**PLAN COMMISSION
MEETING NOTICE AND AGENDA
Thursday, June 18, 2026
6:00 PM**

Pewaukee City Hall Common Council Chambers
W240N3065 Pewaukee Road, Pewaukee, WI

To: File
From: Magdelene J. Wagner, P.E.
Subject: Williams Residence – N27W27136 Woodland Drive
Mitigation Plan
Date: June 8, 2026

Date: May 28, 2026
To: Cold Noses Sanctuary Property LLC
From: Nick Fuchs, Planner & Community Development Director
RE: Staff Comments - Site & Building Plan Review

MITIGATION PLAN
M1.0

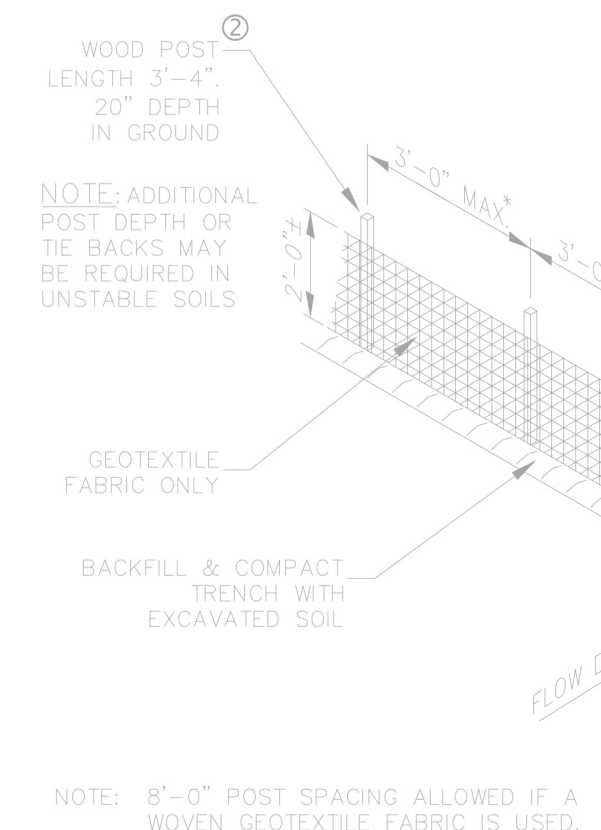
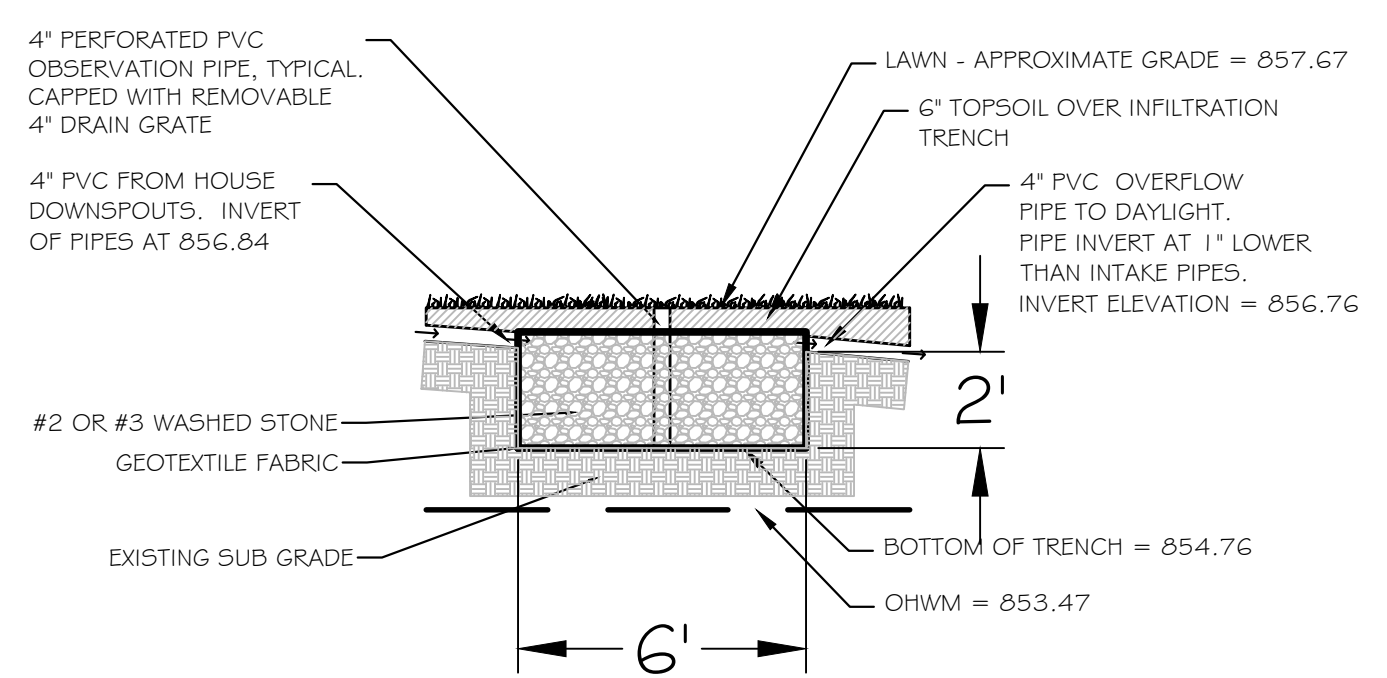
The infiltration trench is adequately sized to provide the required mitigation.

We approve the mitigation plan contingent on the following:

1. The mitigation plan narrative, plan, and the Plan Commission minutes are recorded at Waukesha County (City provided a recorded copy) as required in the ordinance using the Recording Template previously provided to the owner.

SHEET:
SITE PLAN

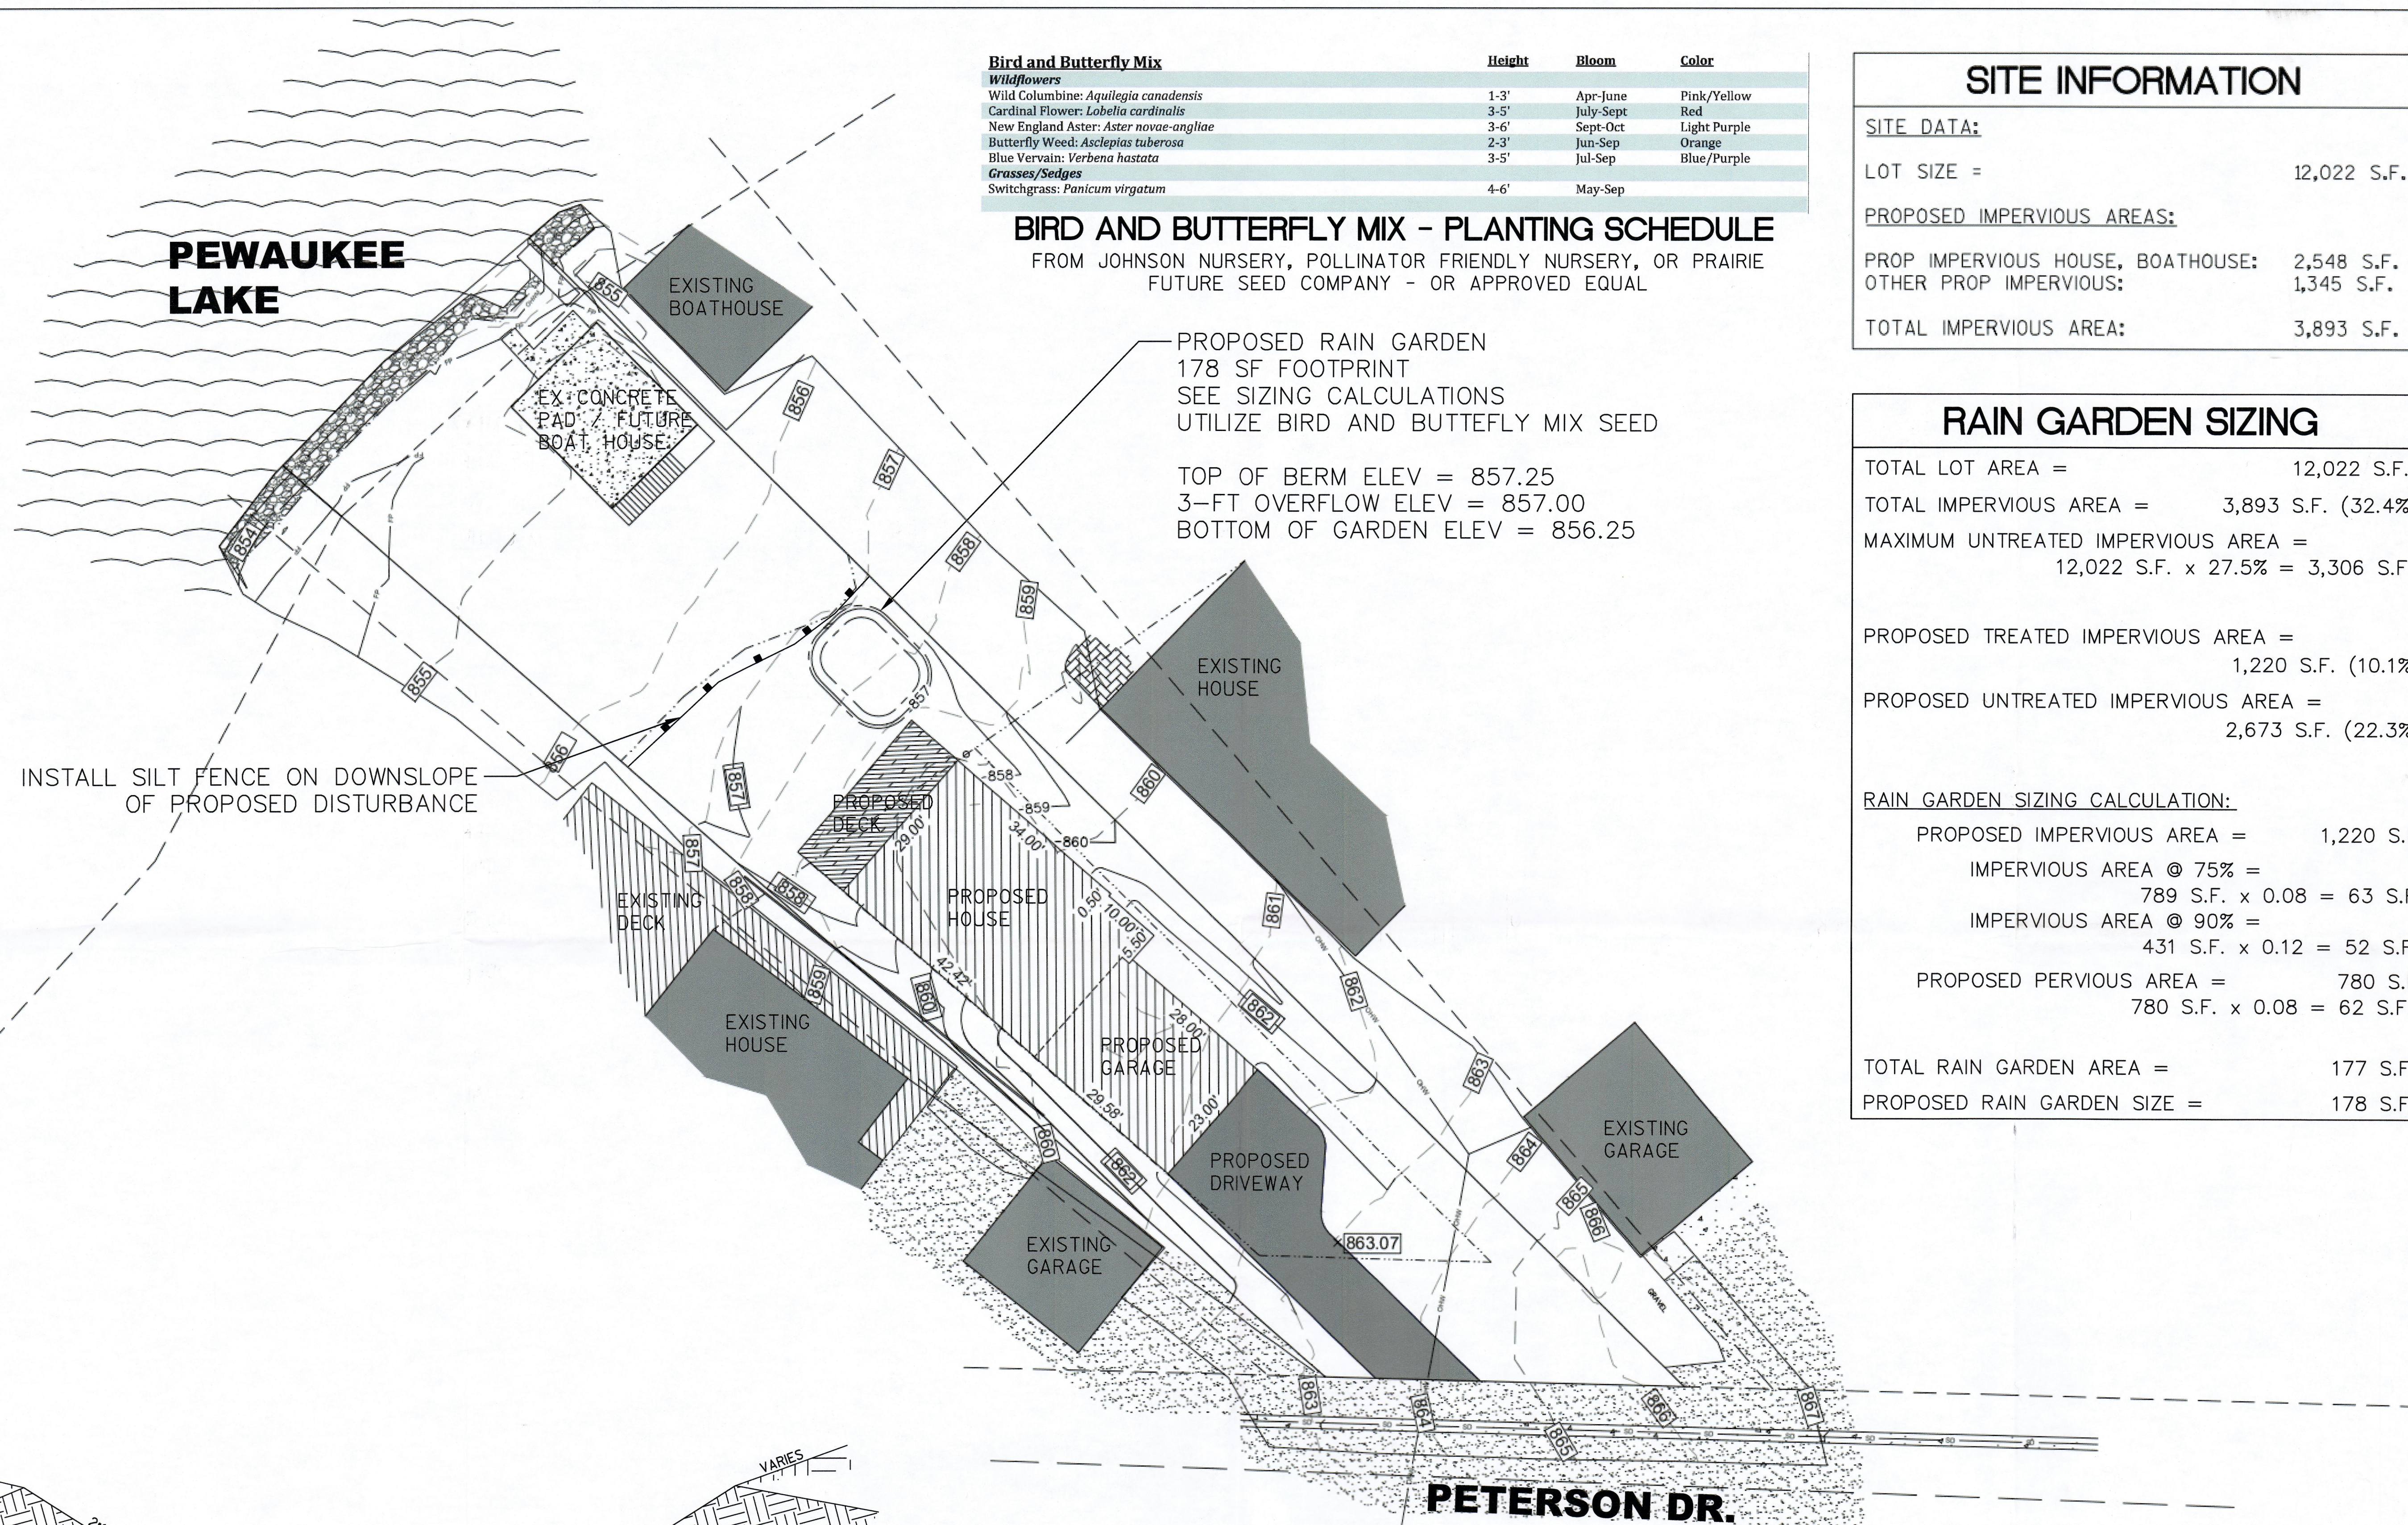
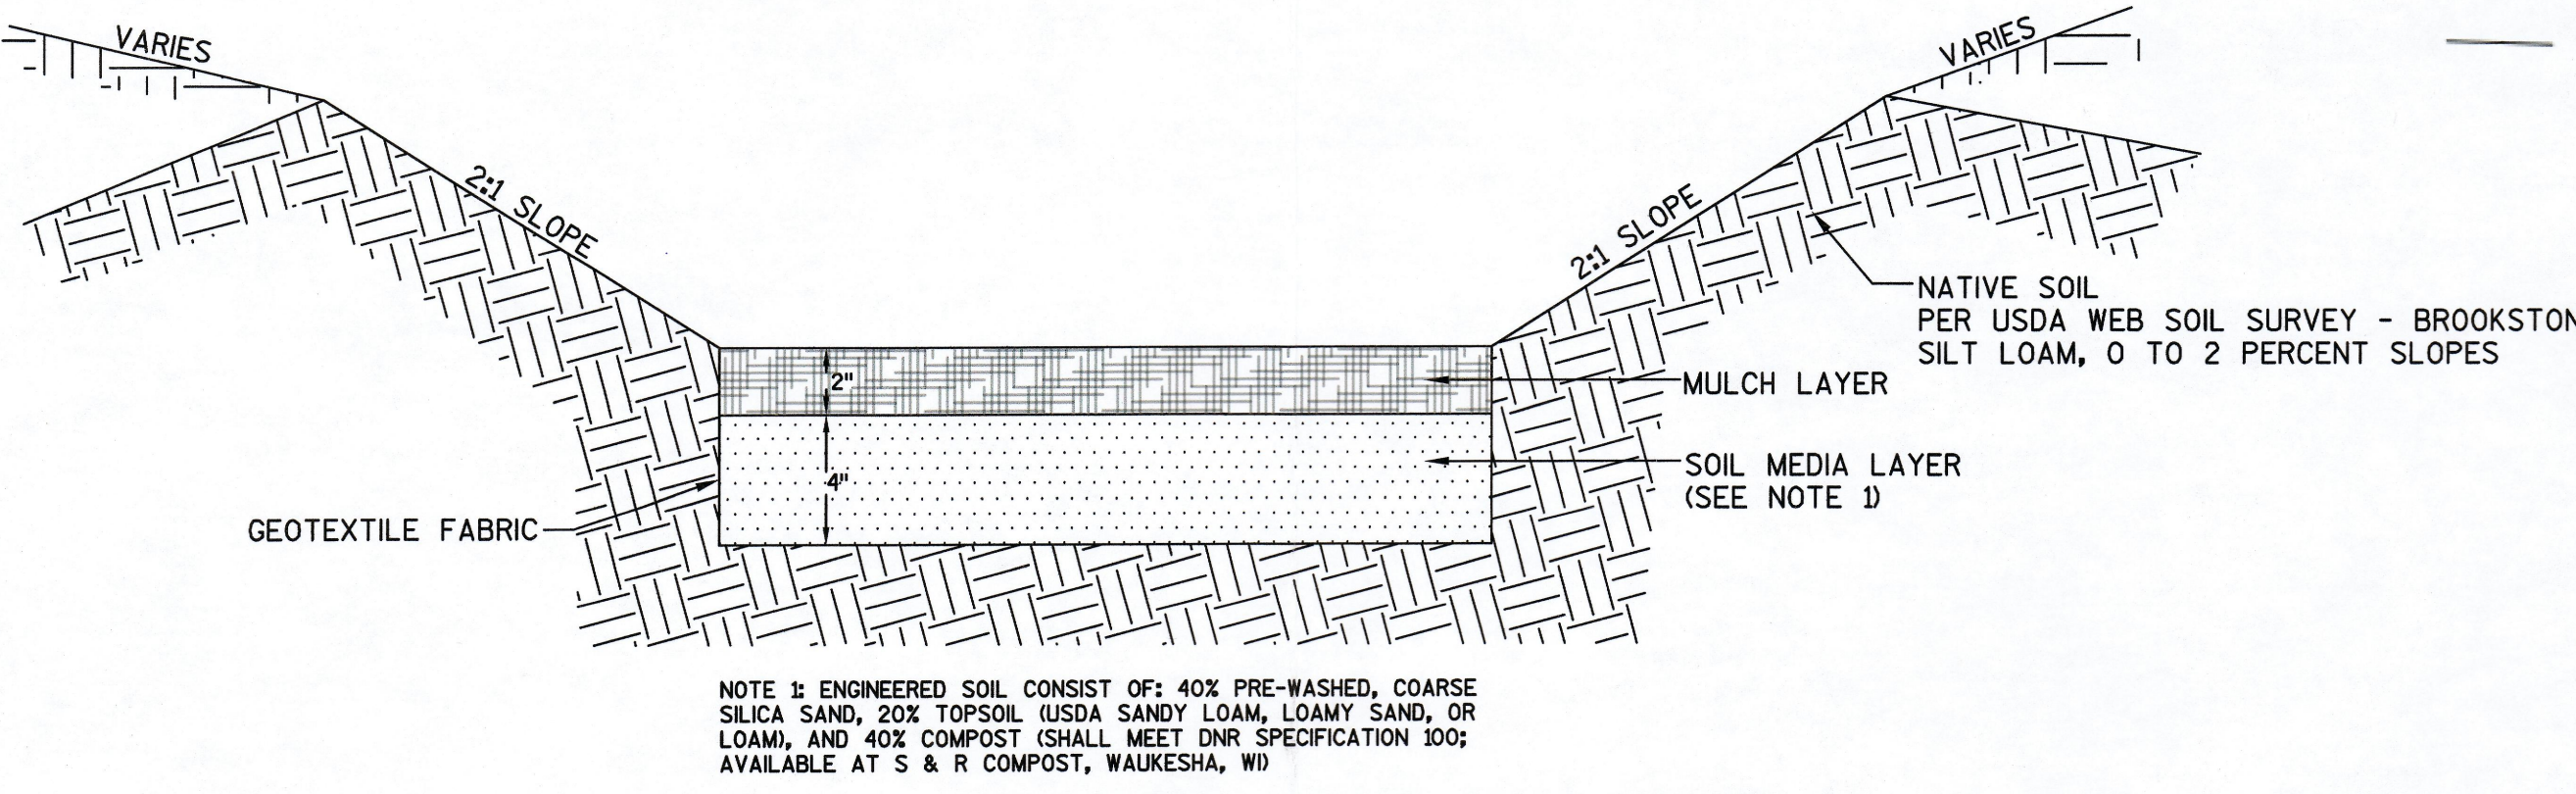
The rain garden is adequately sized to provide the required mitigation.

We approve the mitigation plan contingent on the following:

1. The mitigation plan narrative, plan, and the Plan Commission minutes are recorded at Waukesha County (City provided a recorded copy) as required in the ordinance using the Recording Template previously provided to the owner.

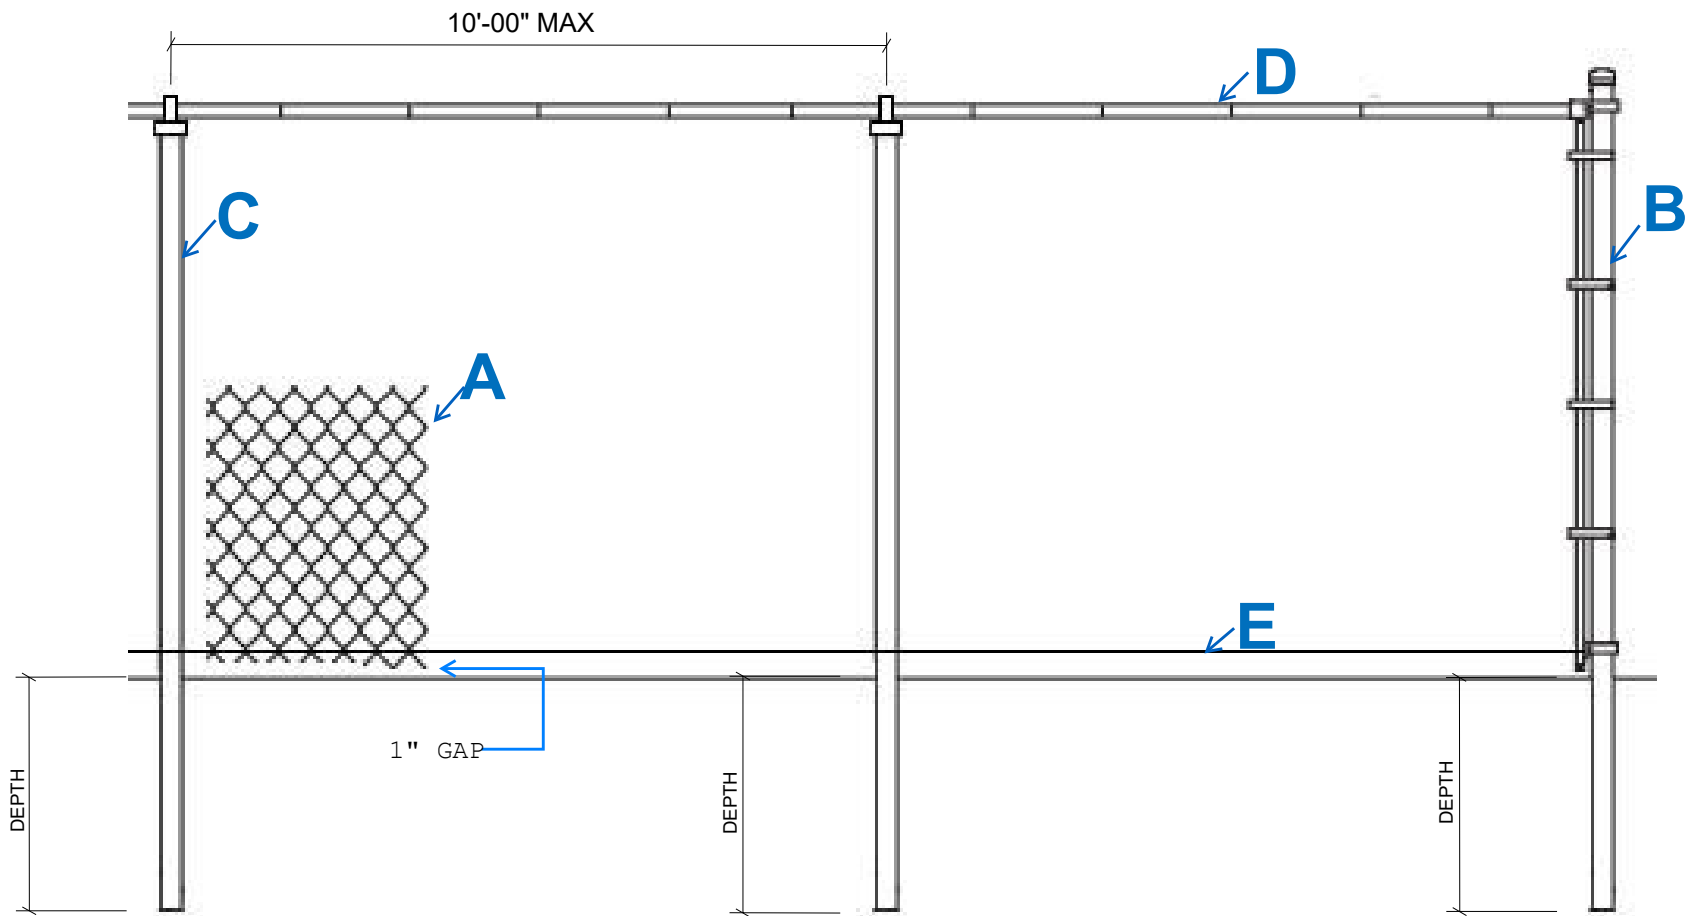
The applicant provided a landscaping concept for Plan Commission consideration. If acceptable, *staff recommends that a complete and detailed landscape plan be provided for staff review and approval.* The final landscape plan must show the entire site/planting area and include a plant schedule listing the quantities, planting sizes, and types of plants that will be installed. Note the M-4 District requires that "[a]ll parking and loading areas shall be adequately screened as determined by the Plan Commission."

The proposed landscaping will extend along the entire length of the fence, except along the north side as indicated by the applicant.

Staff recommends approval of the subject Site & Building Plan Review Application to allow for the installation of the fence as presented.
